# Access Compliance Report

## Public Rights-of-Way

Intersection ID: 54374	Main Street: GRIER_RD	Cross Street: OLD_CONCORD_RD	Location: NE
ADA ID: BED827697F70	Ramp Type: Perp	Initial Pass/Fail: Fail	Overall Compliance: No
			Severity Score: 21.25

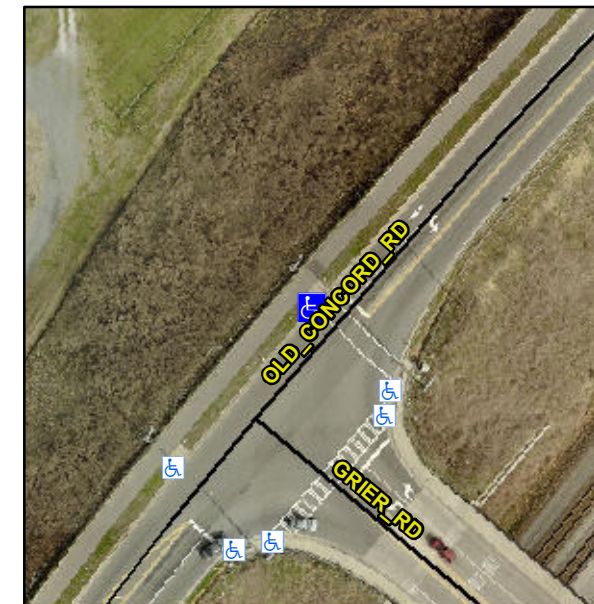
**Not Found, R304.5.1, R304.2.2**

Compliance	Description	Data	Compliance	Description	Data
N/A	Ramp Length (in)	79.0	No	Ramp Slope (%)	8.8
No	Ramp Width (in)	47.0	Yes	Ramp XSlope (%)	1.6
N/A	Flare Type LT	N/A	N/A	Flare Type RT	N/A
N/A	Flare Slope LT (%)	N/A	N/A	Flare Slope RT (%)	N/A
N/A	Flare Traversable LT?	N/A	N/A	Flare Traversable RT?	N/A
N/A	Landing Length (in)	N/A	N/A	DWS Provided?	N/A
N/A	Landing Width (in)	N/A	N/A	DWS Contrast?	N/A
N/A	Landing Slope (%)	N/A	N/A	DWS Length (in)	N/A
N/A	Landing X Slope (%)	N/A	N/A	DWS Full Width?	N/A
N/A	Landing Curb? (Y/N)	N/A	N/A	DWS Offset (in)	N/A
N/A	Shared Landing?	N/A			
N/A	Gutter Ponding?	N/A	N/A	Gutter Slope (%)	N/A
N/A	Gutter Lip Ht (in)	N/A	N/A	Gutter X Slope (%)	N/A
N/A	Painted X Walk1?	Yes	N/A	Painted X Walk2?	N/A
	X Walk 1 Direction	To SE		X Walk 2 Direction	N/A
N/A	X Walk 1 Width (in)	103.5	N/A	X Walk 2 Width (in)	N/A
	X Walk 1 Slope (%)	4.3		X Walk 2 Slope (%)	N/A
	X Walk 1 X Slope (%)	0.0		X Walk 2 X Slope (%)	N/A

**Remove & Replace Entire Ramp.**
